Department
of Energy &
Climate Change

Government response to the consultation on reviewing the qualification criteria for renewable Combined Heat and Power schemes

Response to the December 2012 consultation and the January 2013
supplementary questions

July 2013

Figure 1. proportion of renewable CHP schemes exceeding specified heat efficiencies

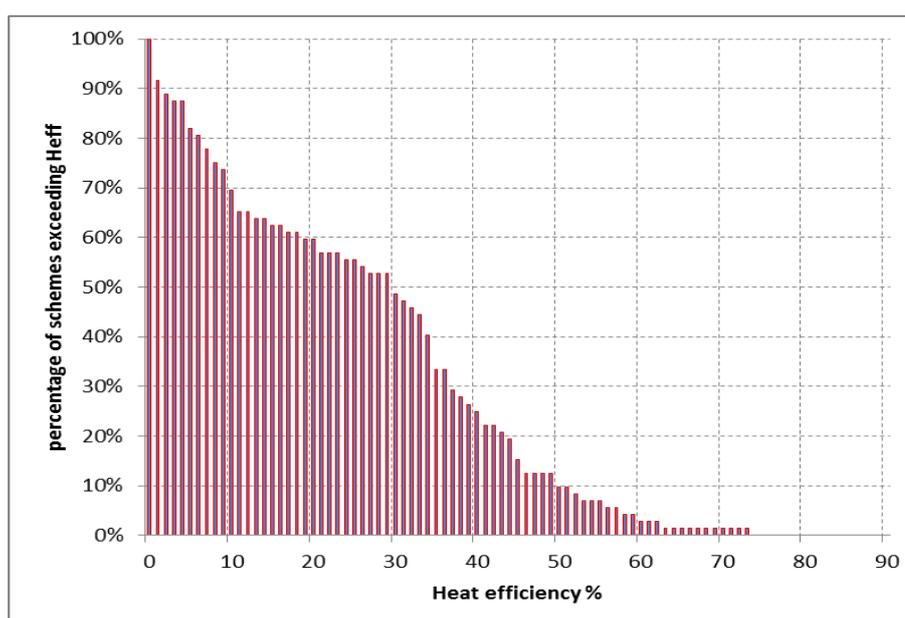
- 1.4 A number of consultees disagreed with the three performance criteria used in deriving the QI formulae. Most of these felt that the 10% heat efficiency was too demanding and that a 5% requirement should be used instead. In particular they noted that even industrial heat loads were seasonal and that an annual average efficiency of 10% implied a higher peak efficiency. A smaller number of consultees felt that these criteria were insufficiently demanding and in particular that a higher overall efficiency requirement should be specified.

- 1.9 It is true that the 10% heat efficiency criterion applies as an annual average and therefore, accounting for seasonal variation, the peak heat efficiency has to be greater than 10% to meet this criterion. However, more than two thirds of solid and liquid renewable fuel CHP schemes already certified to CHPQA meet this criterion, despite the existing arrangements not providing a strong incentive to maximise heat load. Consequently we are of the view that an annual heat efficiency of 10% is a reasonable minimum requirement for new plant to fully qualify as Good Quality CHP.

Figure.2 Illustration of potential discontinuity in QI introduced by safeguard provision

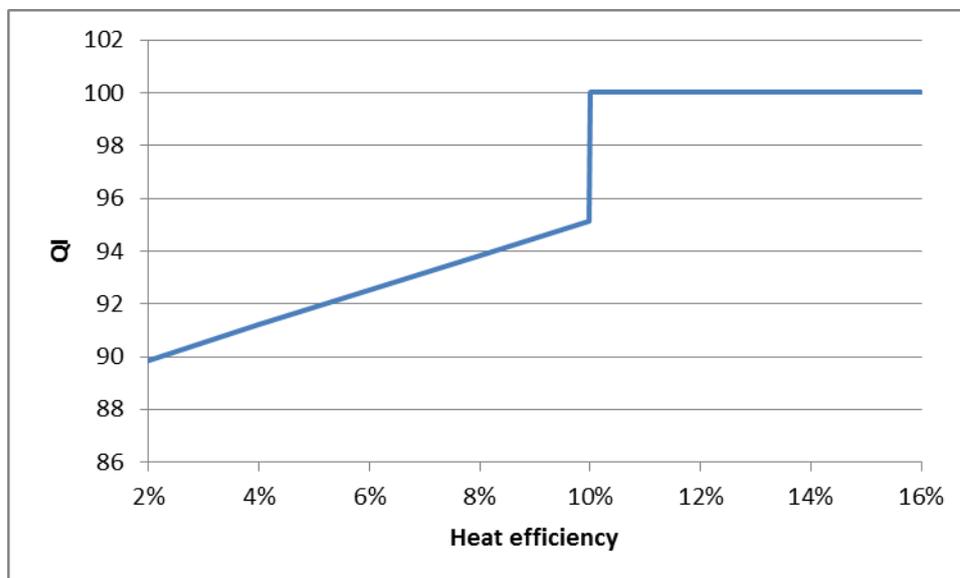
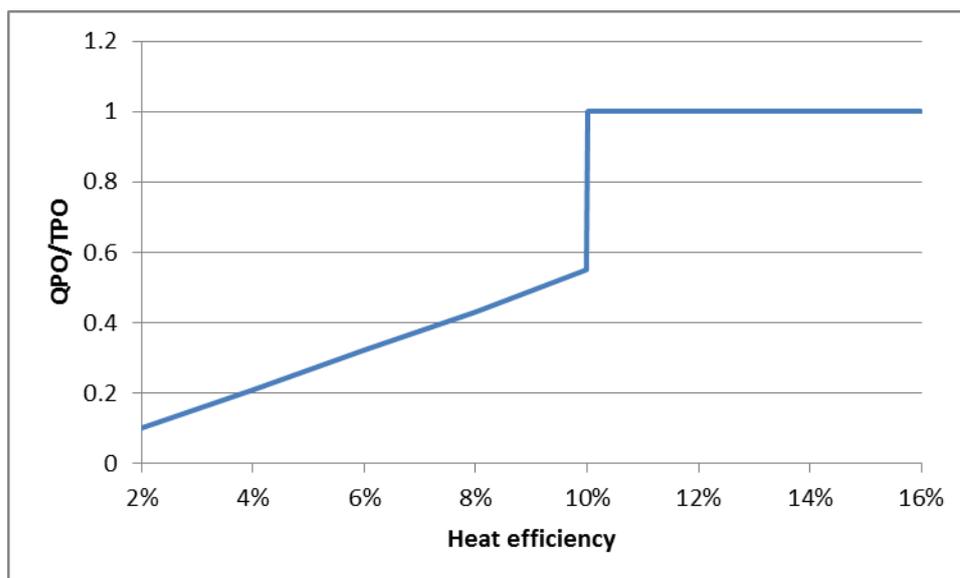
- 2.4 Several stakeholders noted that, whilst welcome, the introduction of the safeguard provision introduced something of a cliff-edge in the qualification criteria. For example, if a scheme achieved a QI of 100 by virtue of the safeguard provision and subsequently suffered a small reduction in performance, such that one or more criteria were just missed, it would revert to being assessed on the QI formulae. Since the scheme qualified via the safeguard provision the QI formulae will produce a (possibly significantly) lower QI and Qualifying Power Output (QPO). This is illustrated in Figures

2 and 3 (showing QPO as a proportion of Total Power Output (TPO)) below in the case of varying heat efficiency. This contrasts with the linear reduction in QI where the formulae alone are used with no safeguard provision.

- 2.7 We acknowledge that the safeguard provision as proposed in the consultation does introduce something of a cliff-edge into QI and hence to the extent to which a scheme qualifies as Good Quality. **We will therefore implement a specific scale back procedure for new schemes which need to use the safeguard provisions to fully qualify.** This procedure will be based on determination of the operating point at which a scheme would just meet all three policy criteria and recalculation of the X coefficient in order to give a QI of 100 at this point. Scaleback of Qualifying Power Output will then be conducted using the normal CHPQA rules. The recalculation of the X coefficient will be a once-only event based on a scheme's design data. An example of this procedure is shown below.
